CHANGE ORDER NO.: 4

Owner:	Town of Bristol	Owner's Project No.:	WW22532001
Engineer:	Commonwealth Engineers, Inc.	Engineer's Project No.:	S22145
		Contractor's Project	
Contractor:	Crosby Construction	No.:	24105-01
Project:	WWTP Improvement Project		
Contract Name:	WWTP Improvement Project

Description: Installation of a new manhole at Lift Station #8 and the NIPSCO-requested adjustment of the transformer. Location onsite.

SUBJECT: Wastewater Treatment Plant Improvements
Work Item Breakdown for Change Order No. 4

EXISTING LIFT STATION
NO 8. SITE DEMOLITION
PLAN (MA3)

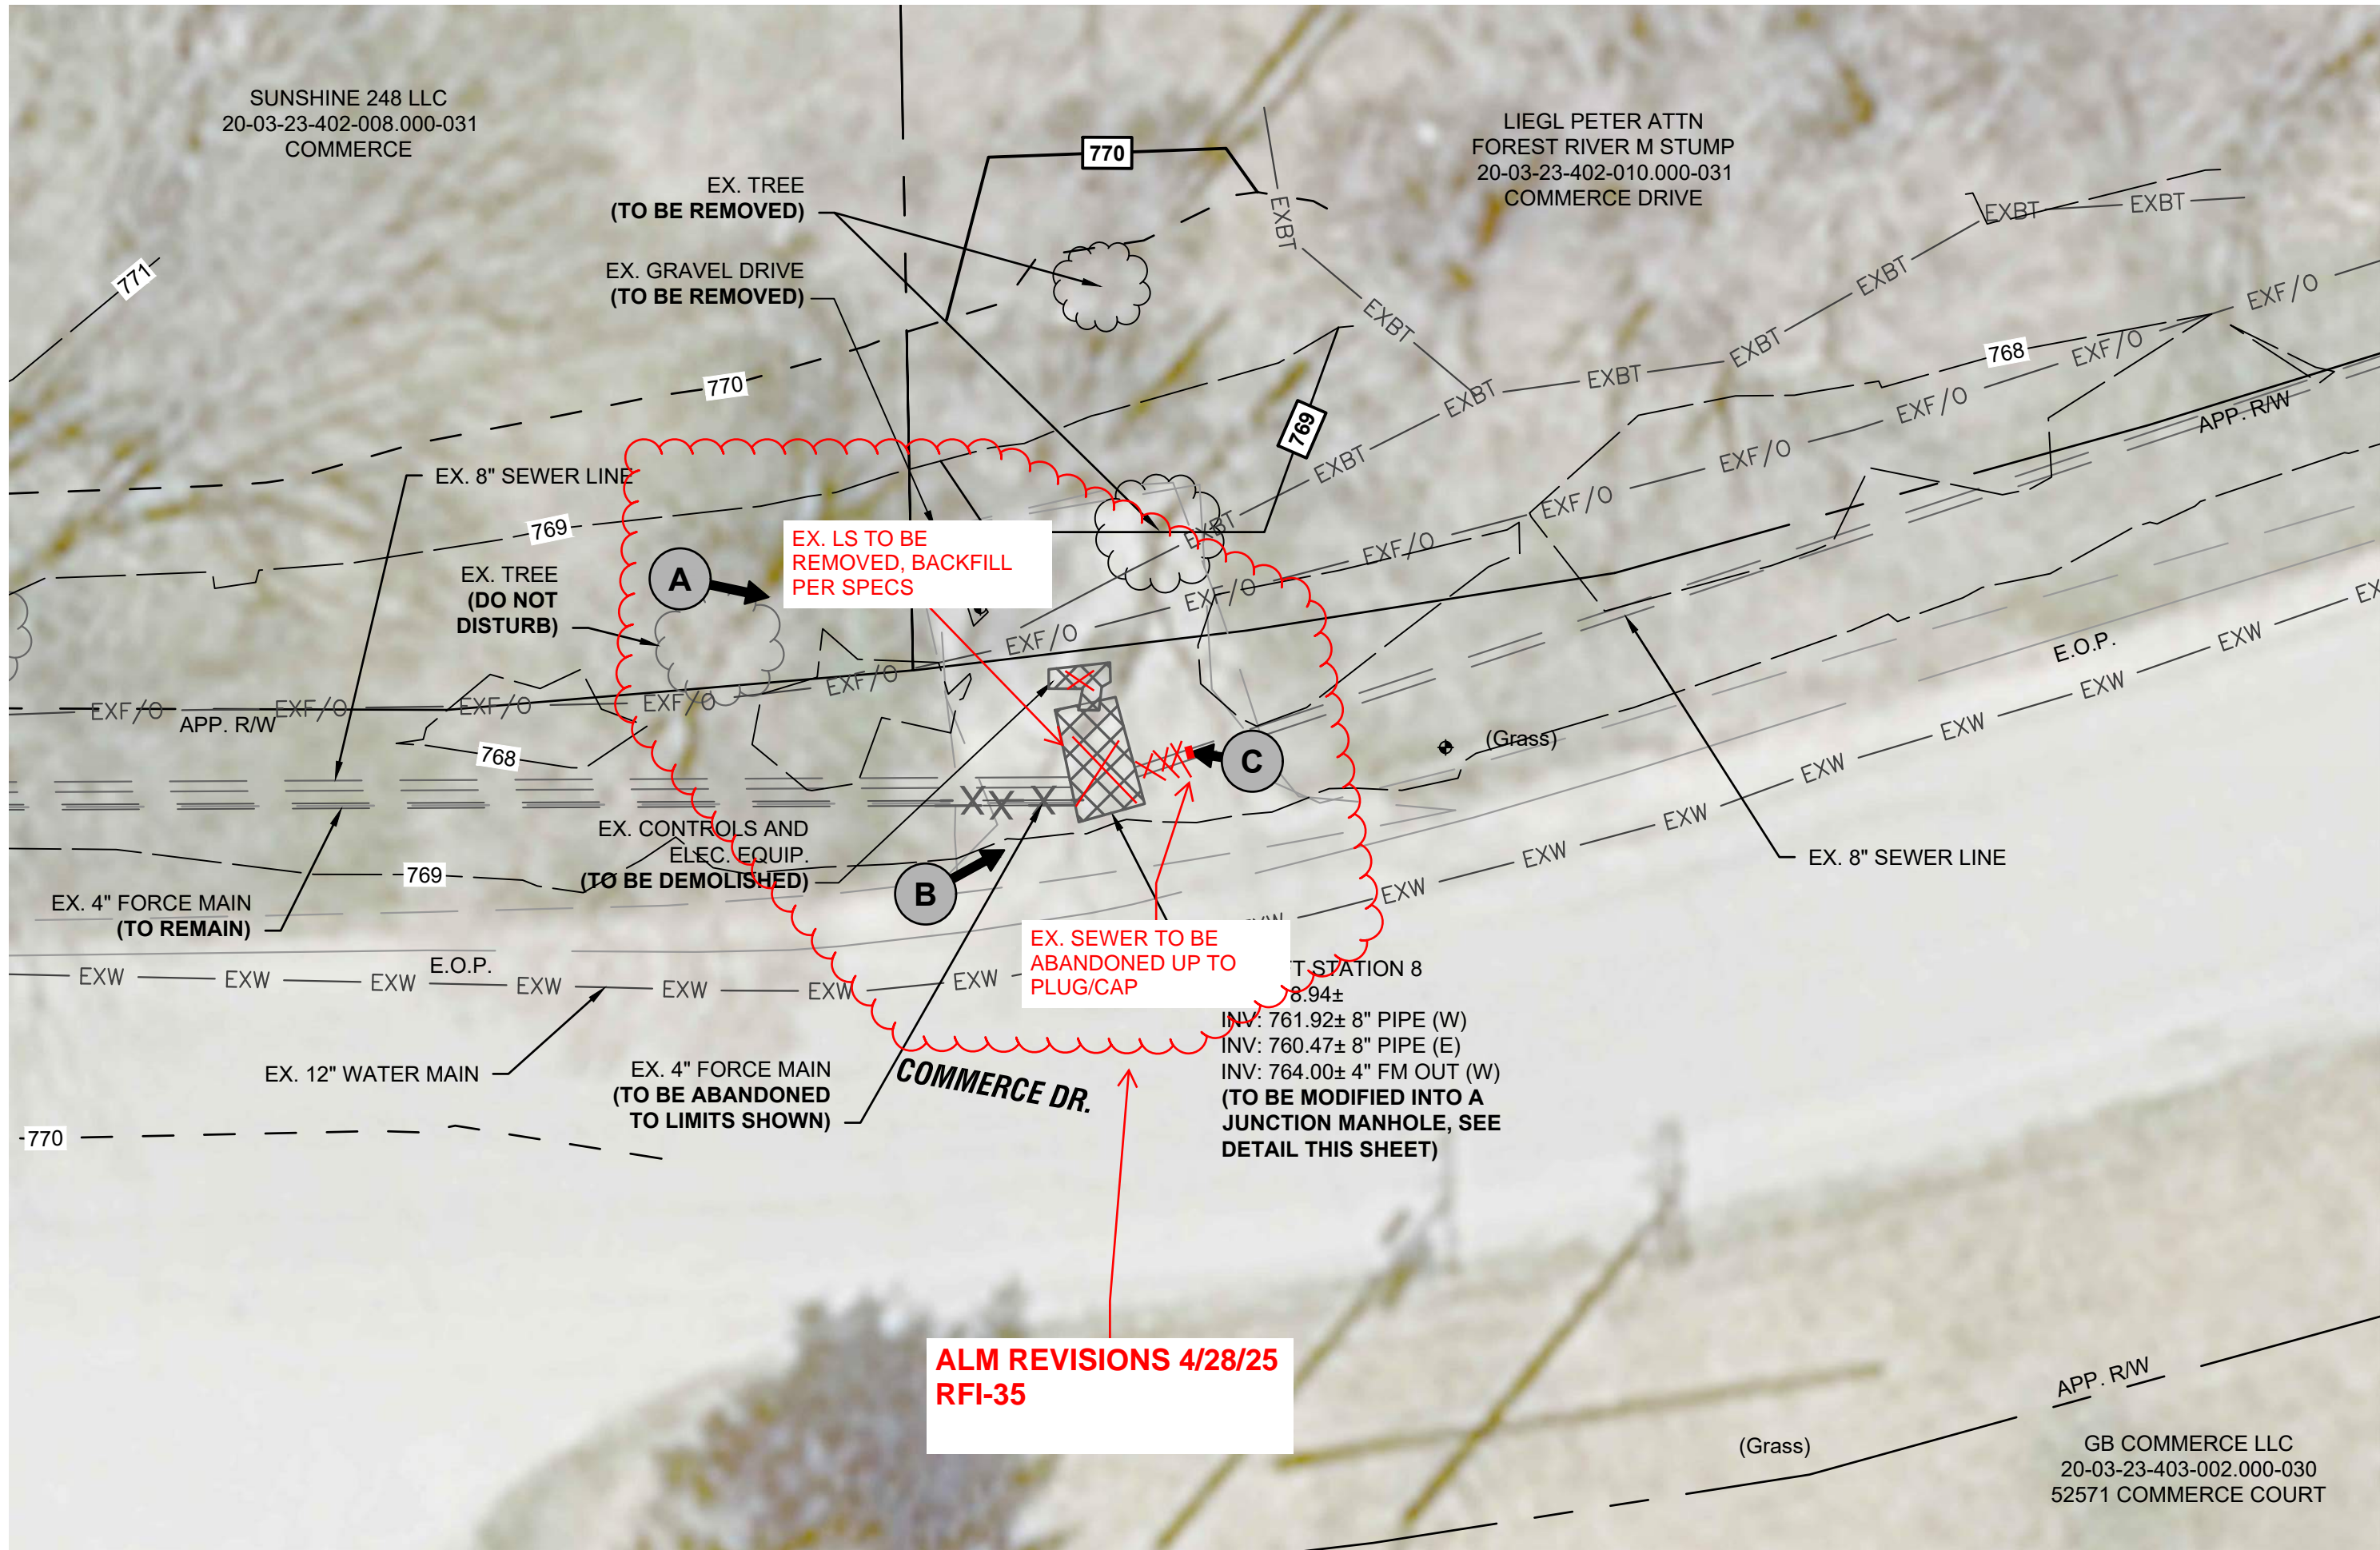
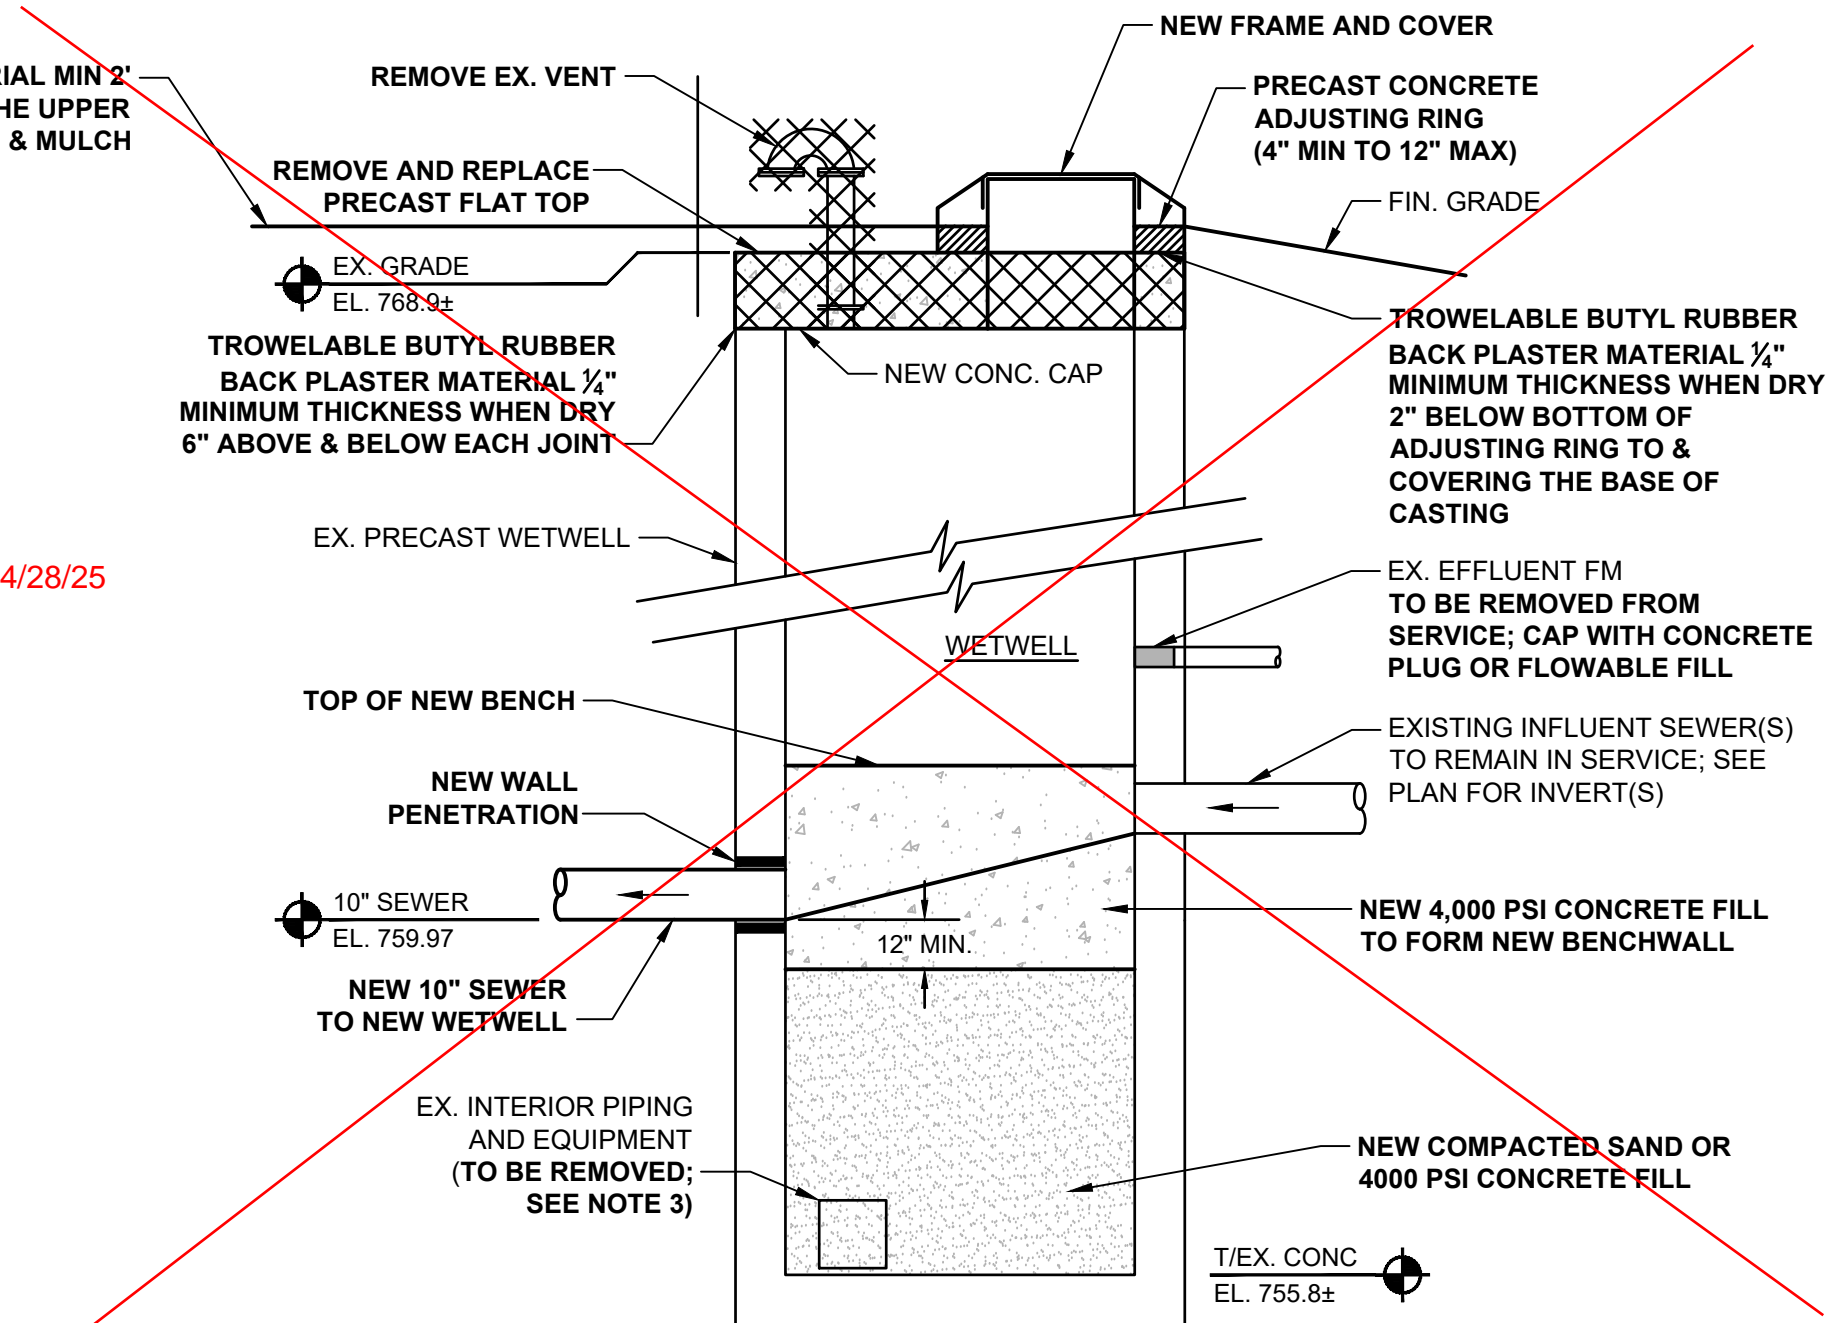
ALM REVISIONS 4/28/25
RFI-35

MODIFICATION OF EX. WET WELL TO JUNCTION MANHOLE
NOT TO SCALE

Job: Bristol XFMR Re-locate

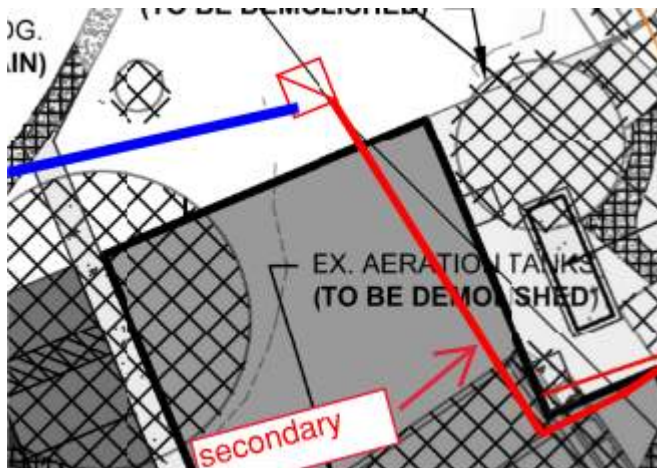
- After meeting with NIPSCO on site and reviewing transformer location on the drawings and the location of future structures. NIPSCO indicated due to primary routing and accessibility they do not want the transformer located as shown on the drawings they would like to relocate it to the location shown below. This will add length to our secondary feeders.
- Added cost for extending permanent feed to new transformer location on the west side of the building per NIPSCO's requirement.
- Includes added cost for extending the conduit and wire. (3) sets of 4 wire 500MCM in 4" PVC conduit

Response from Jack Sizemore Commonwealth Engineers Inc. (Indy) on Wednesday, May 28, 2025 at 08:06 AM EDT
Commonwealth acknowledges and approves the costs associated with relocating NIPSCO's transformer.
